**Comments of Public Service Company of New Hampshire
on EPA's Draft National Pollutant Discharge Elimination
System Permit No. NH 0001473 for Schiller Station**

Permit No. NH0001473

Schiller Station

Figure 2-1: Example illustrating the decline in abundance of Winter Flounder life stages from spawning to adulthood based on published life history parameters³.

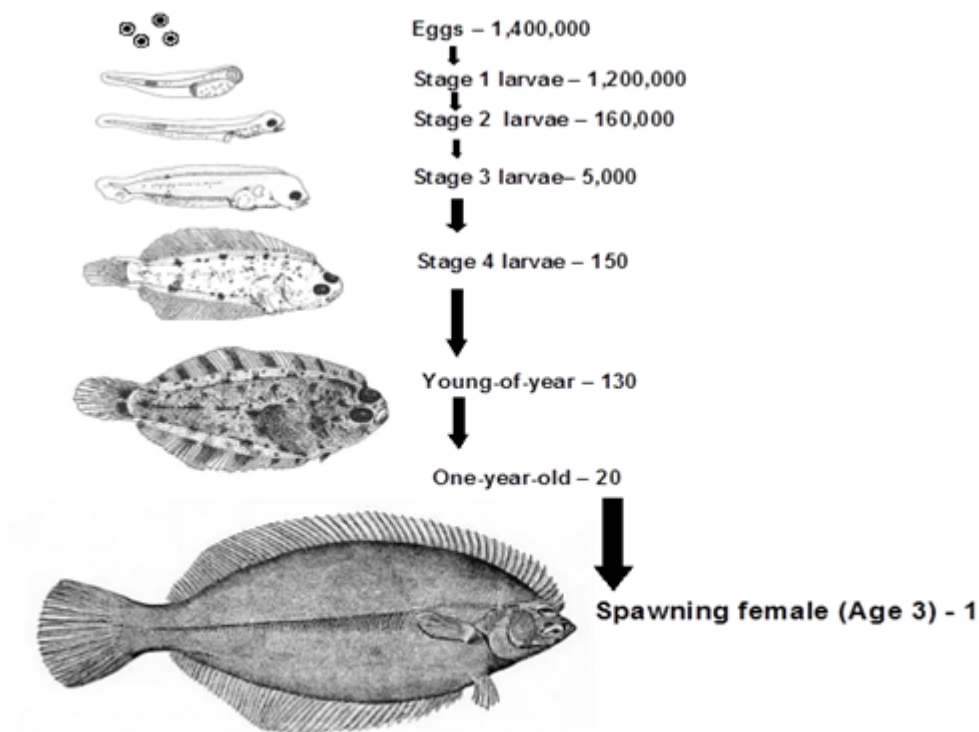
Figure 2-1 in the 2016 Enercon-Normandeau Comments depicts the survivorship curve of the Winter Flounder and puts the above-referenced comments in proper context by demonstrating

that a miniscule number of eggs and larvae of organisms subject to entrainment at Schiller Station would survive to adulthood even in the absence of the facility's CWISs:

Only one out of 1.4 million Winter Flounder eggs is likely to survive in waters similar to the Piscataqua River to become a three-year-old spawning fish—one.¹¹⁸ Moreover, nearly 99 percent of the eggs die of natural causes within 60 days following spawning. Remarkably, fecundities of other abundant fish and macrocrustacean taxa typically entrained by CWISs at Schiller Station are roughly equivalent to the Winter Flounder and/or are comparatively higher than the median taxa. Furthermore, like the Winter Flounder, early life stages of these other abundant fish and macrocrustacean taxa typically entrained by the facility's CWISs also

Figure 4-1: Plot of cumulative AIF in MGD (Ref. 7.6)

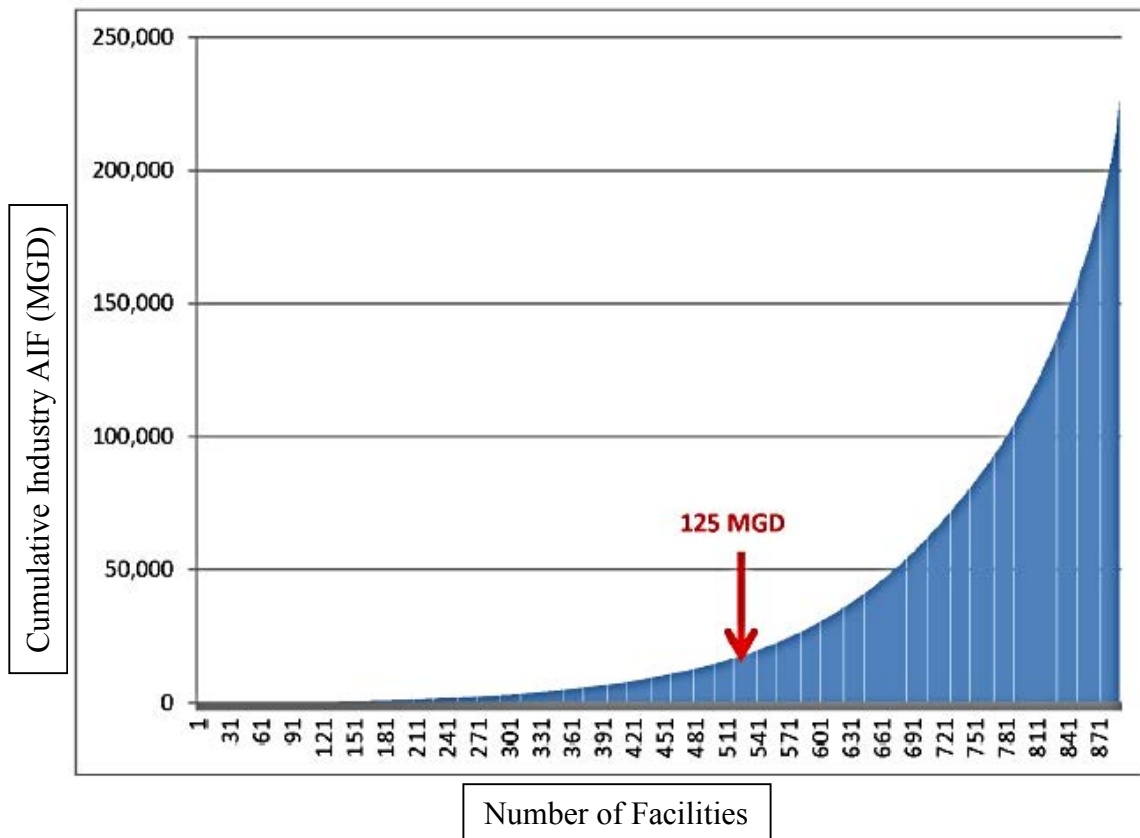
The figure of interest (Figure 4-1) is provided below. This figure shows that the vast majority of water used by existing facilities in the United States is withdrawn by the biggest users. The horizontal axis shows a listing in facilities in increasing order, and the cumulative AIF (total water withdrawn by all facilities up to that point) is displayed on the vertical axis.

Therefore, EPA appears to have concluded that the 125 MGD AIF threshold for submittal of entrainment-related information was a policy decision to achieve the greatest nationwide entrainment reduction at the lowest cost to the industry. By this logic, EPA focuses on the largest users of water and limits the burden on smaller facilities.

Figure 4-3: Existing facilities and flow addressed by various flow thresholds (Ref. 7.6)

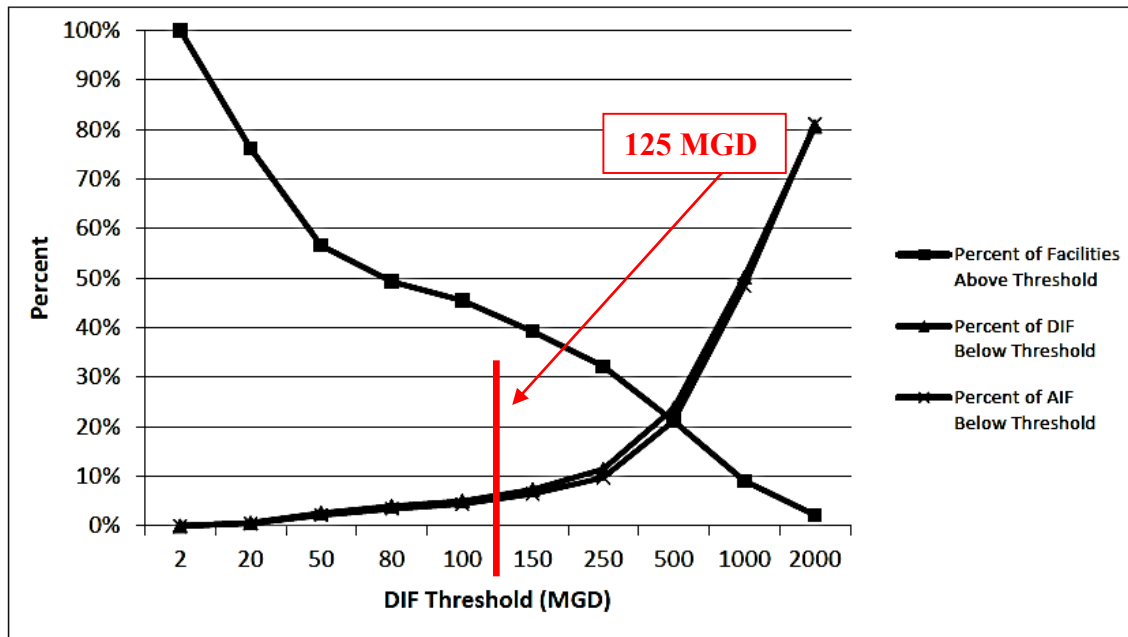
Figure 4-3 illustrates that approximately 42 percent (from visual inspection) of facilities considered by EPA would be subject to the information requirements of a 125 MGD DIF threshold. Additionally, Figure 4-3 also illustrates that such a threshold would capture all but approximately 6 – 7 percent (from visual inspection) of the total industry AIF and DIF. Put differently, such a threshold would capture 93 – 94 percent of all industry AIF and DIF. From Figure 4-3, it appears that EPA’s logic to establish a 125 MGD AIF threshold is to encourage facilities to utilize operational measures to reduce intake flow (Reference 7.6). The 125 MGD threshold represents a policy decision by EPA to produce the greatest entrainment reduction in a way that affects less than half of the industry.
